**CHANGE ORDER FORM
(ATTACHMENT A TO SPECIAL CONDITIONS)**

Project: LPC Temporary Faculty Village Project
Date: March 11, 2021
Contractor: Sausal Corporation

Change Order: #01
Contract #: B210281

Project Name: Las Positas Temporary Faculty Village
Project Number: 863-0005
ID: ASI 001
Date: 12/11/2020
Subject: Revision 001 FFE adjustment at Modulars and Removal of Walkway Roof

FA2.10

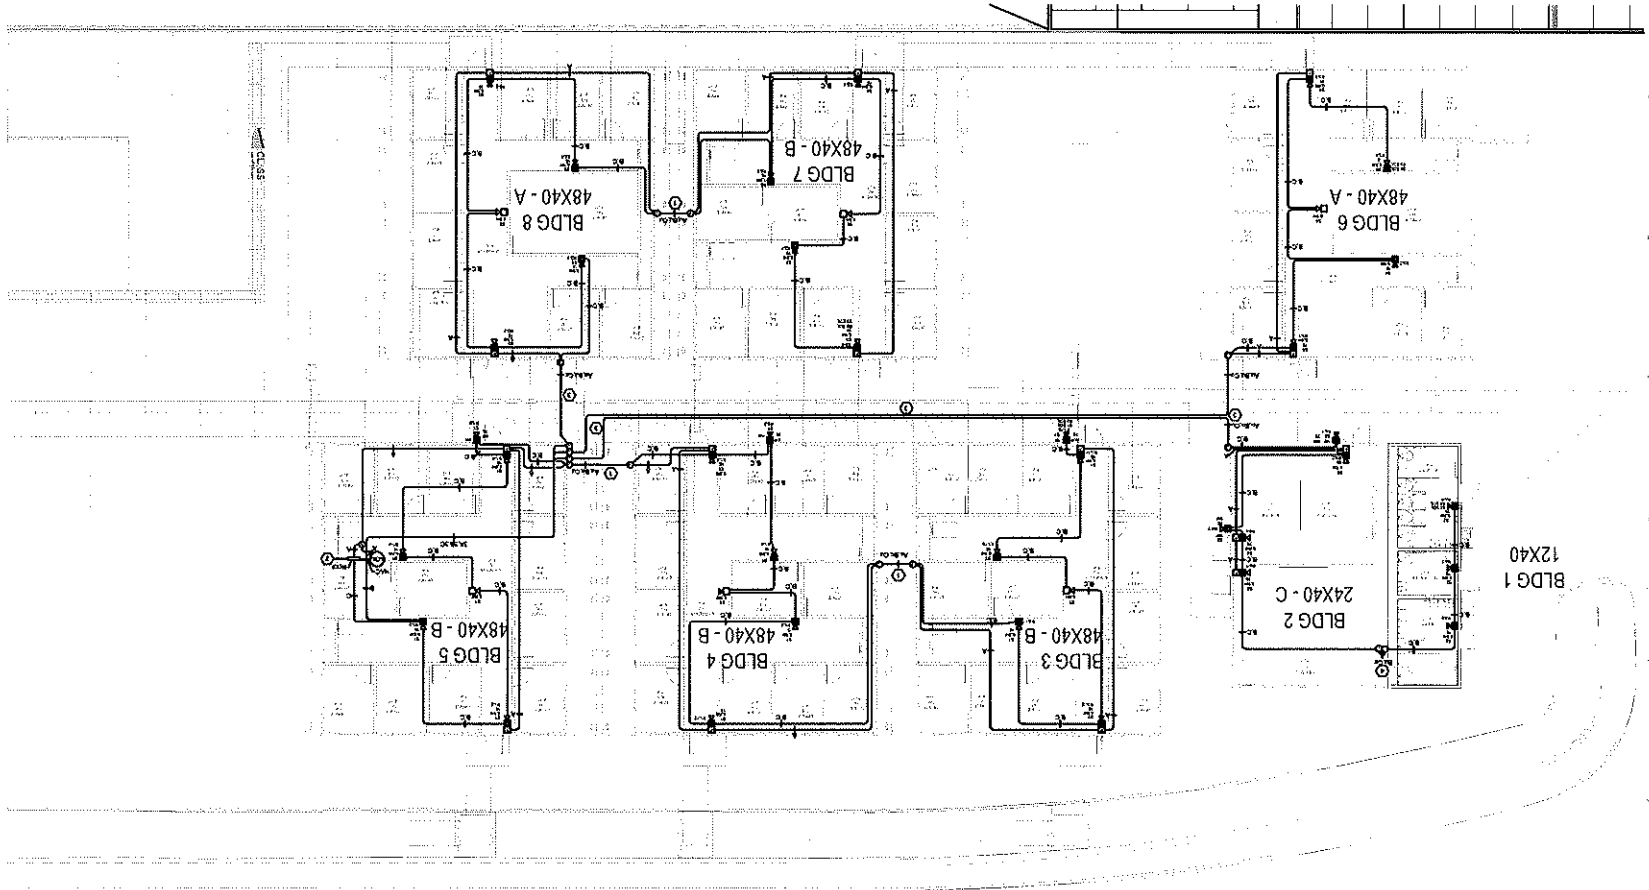
- FA2.10s – Updated key note 3 to route conduit under walkway
- Section 00 0110 Table of Contents - edited to remove sections not used.

E1.10s

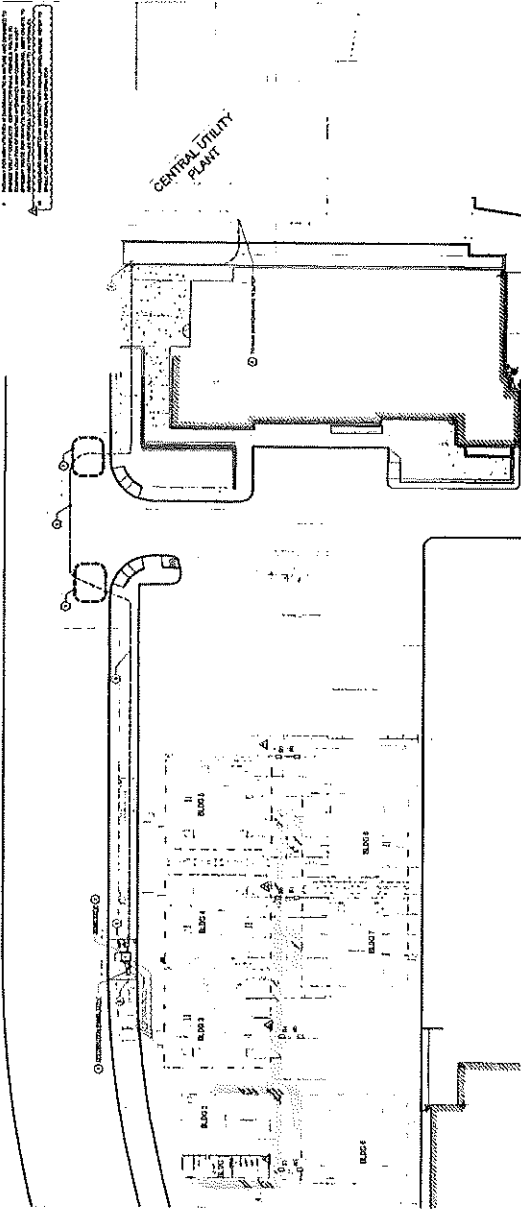
Sheet E1.10s

- Add panel '1LTFV' location
- Add keynote 10

E3.10s

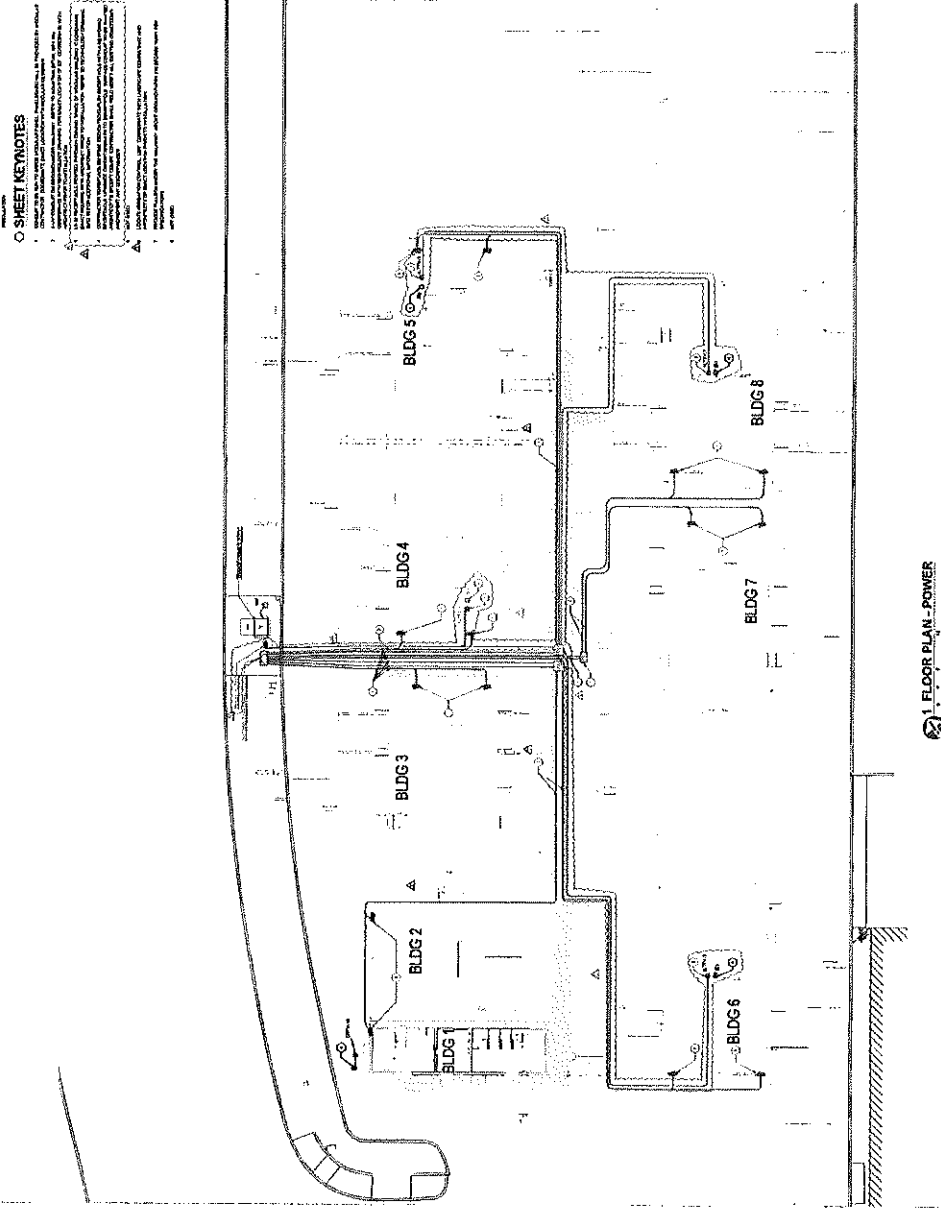
Per ASI 003 - Add panel, breaker, Conduit, Wiring and type L5-30 receptacles at IDF locations shown on sheet E3.10s

Sheet E3.10s

- Revised keynote 3 and 4
- Add panel '1LTFV' location and conduit routing to special receptacle
- Add special receptacle by IT box
- Show existing duplex receptacle by IT box

1. PARTIAL SINGLE LINE DIAGRAM

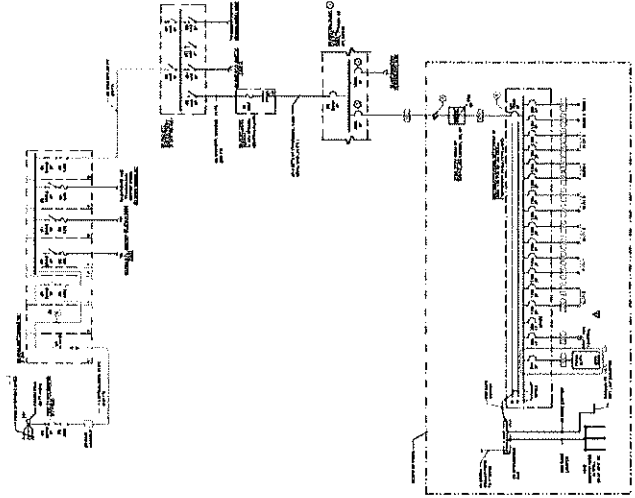
Sheet E4.10s

- Add 60A 3pole breaker for panel '1LTFV'
- Add panel schedule for '1LTFV'
- Add circuit on distribution panel 'DTFV'
